# STATE OF VERMONT
# AGENCY OF TRANSPORTATION

PROJECT LOCATION : LOCATED IN THE COUNTY OF ADDISON, TOWN OF NEW HAVEN & WEYBRIDGE, ON TH 7/11, BR 26 OVER THE OTTER CREEK, AT THE NEW HAVEN - WEYBRIDGE TOWN LINE.

PROJECT DESCRIPTION : THE PROJECT CONSISTS OF REHABILITATING THE EXISTING STRUCTURE INCLUDING ONE NEW ABUTMENT WITH RELATED CHANNEL AND APPROACH WORK.

The following Structural Steel details (Sheet S1) [Item #506.50/60, Structural Steel] for the above project (Vendor's Job #329) that were received in this office on July 9, have been reviewed and are being returned herewith. The expansion joint details (Sheet J1) [Item 516.11 Bridge Expansion Joint, Vermont] that were received on June 11 have also been reviewed and are being returned.

# EXPANSION PREFORMED FABRIC PAD BEARING

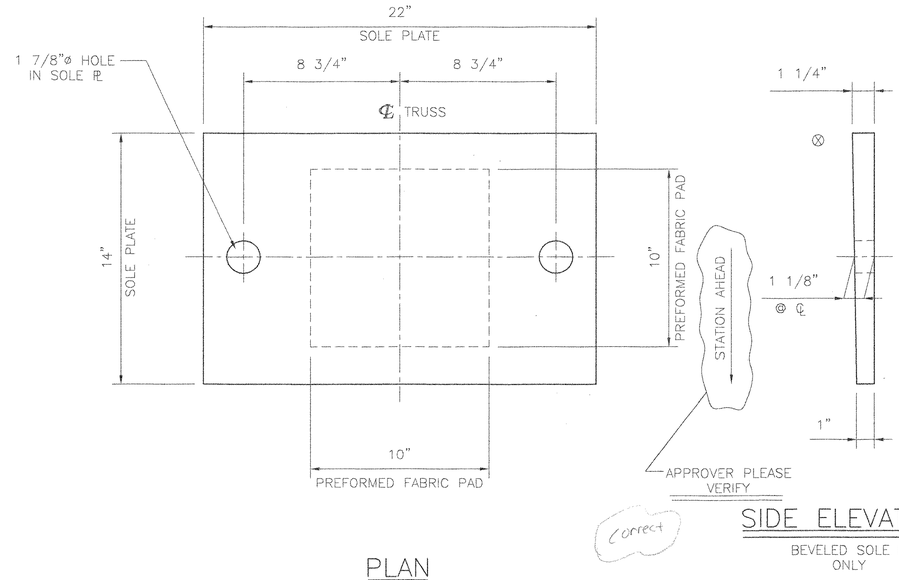
RECEIVED
CK'D BY _____ OK'D BY _____
APR 2 5 2007
RESUBMIT _____ APPROVED AS Noted
BY GPW DATE 5/3/07

JOB: BRIDGE IMPROVEMENTS NEW HAVEN & WEYBRIDGE, VT.

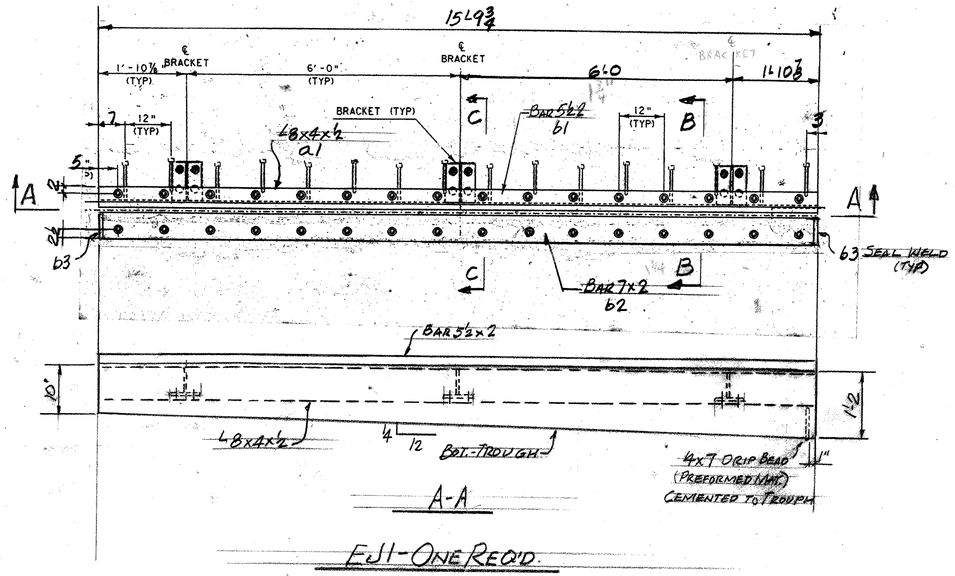
Sheet S1 and J1 are both approved as noted. Please see comments in red on the attached sheet. Weld procedures are also approved.
